UNITED STATES PATENT AND TRADEMARK OFFICE

APPLICATION NO.	FILING DATE	FIRST NAMED INVENTOR	ATTORNEY DOCKET NO.	CONFIRMATION NO.
10/798,140	03/11/2004	Domenic V. Apprille JR.	8127	5560

Office Action Summary	Application No. 10/798,140	Applicant(s) APPRILLE, DOMENIC V. C	
	Examiner Sean M. Michalski	Art Unit 3725

DETAILED ACTION

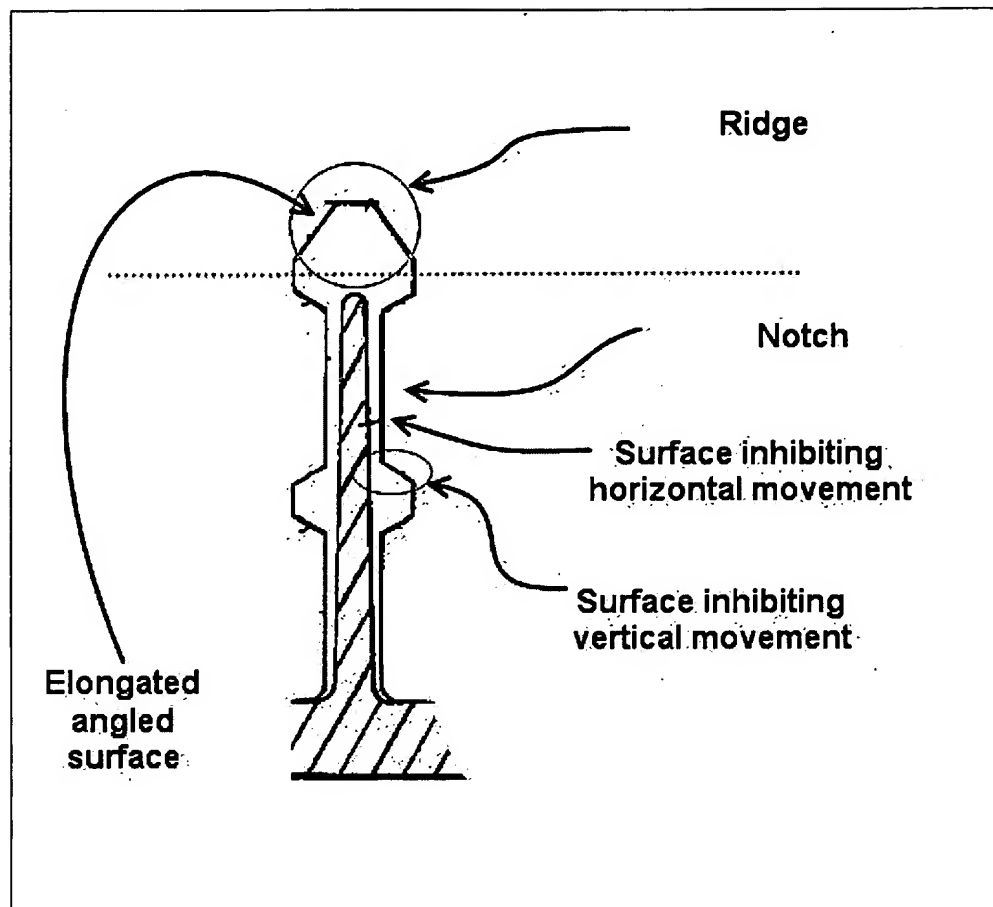
12. Regarding claim 8, Petrillo further discloses that the latch comprises an elongate ridge (see below)

13. Regarding claim 9, Petrillo further discloses a notch (see figure above).
14. Regarding claim 10, Petrillo further discloses surfaces to inhibit movement (see figure above).
15. Regarding claim 11, Petrillo further discloses an elongated angled surface configured to facilitate insertion of a blade unit into the respective section (column 3 line 4).
16. Regarding claims 18 and 48, Petrillo further discloses that the cartridge dividers further include blade unit dividers that extend perpendicularly from the base (200 figure 7) and define blade unit regions in which the blade units are received (see figure 7, the dividers demark the limits of a region within which the blade units 20 are received).

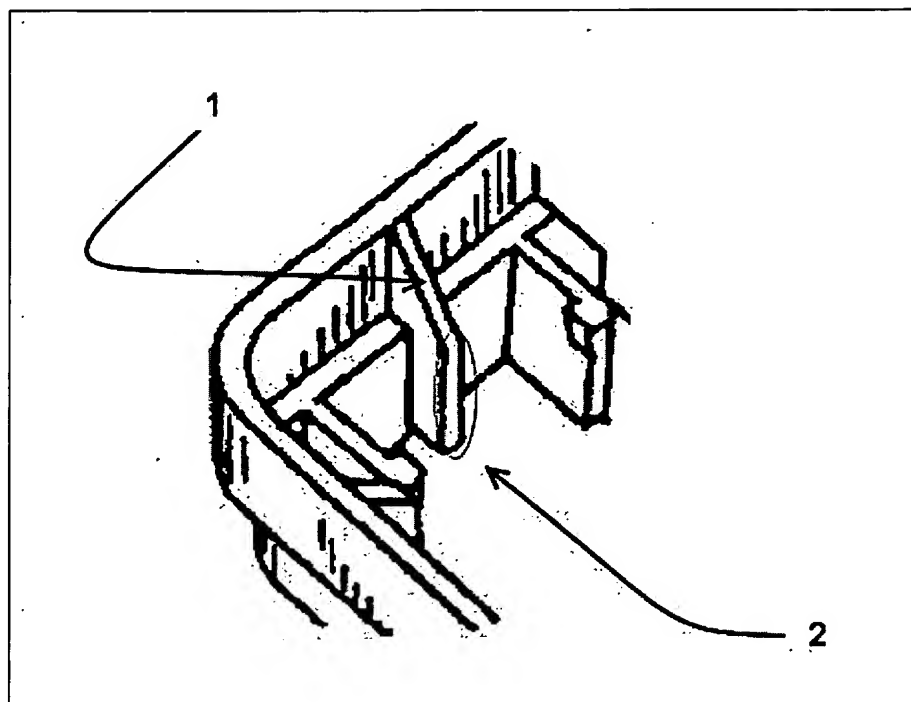
25. Regarding claims 10/4, 10/8, 15/5, 15/13, 40, 45 Kohring further discloses that the latches have two surfaces, seen below, labeled 1 and 2 for convenience.

Surface 1 is positioned to inhibit vertical movement of the protrusion on the blade unit, since it was designed to cam with that surface and prevent it from being located in the area below surface 1 (column 3 lines 35-40). Surface 2 is positioned to inhibit horizontal movement of the respective protrusion on the blade unit. When the blade unit C is in the housing, its movement towards the latch is inhibited by the presence of the latch. The latch prevents the protrusion from moving horizontally out of the housing.

26. Regarding claim 16, 41, 46 Kohring further discloses that each ridge includes an elongated angled surface configured to facilitate insertion of a blade unit into the respective section. Surface 1 (in the figure above) was designed to cam with the blade unit (column 3 lines 35-40).

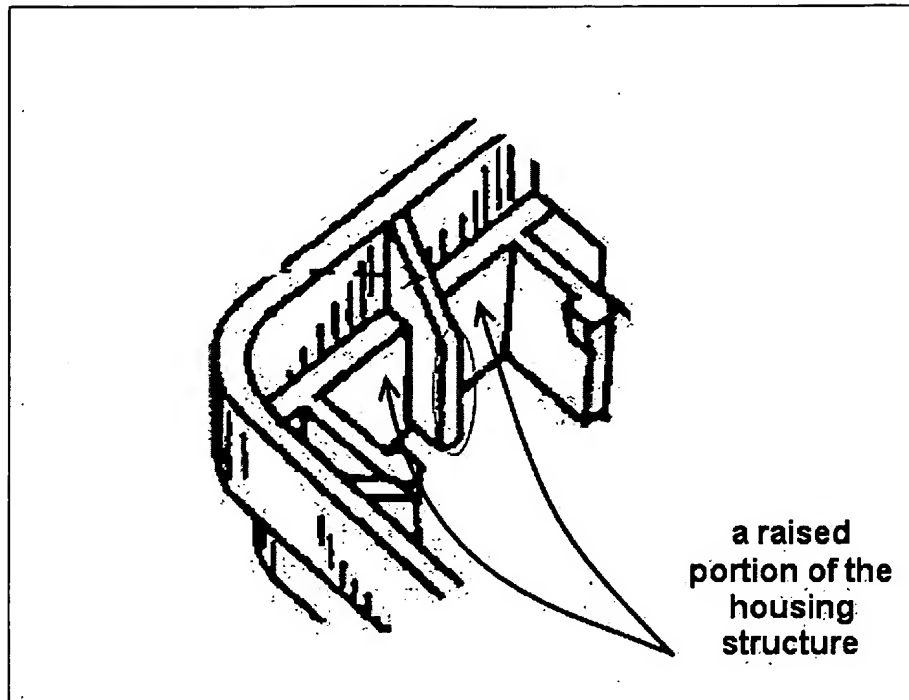
If the latch portion were modified as above, there would still be a raised portion of the housing structure (seen below) which would underlie the elastomer latch.
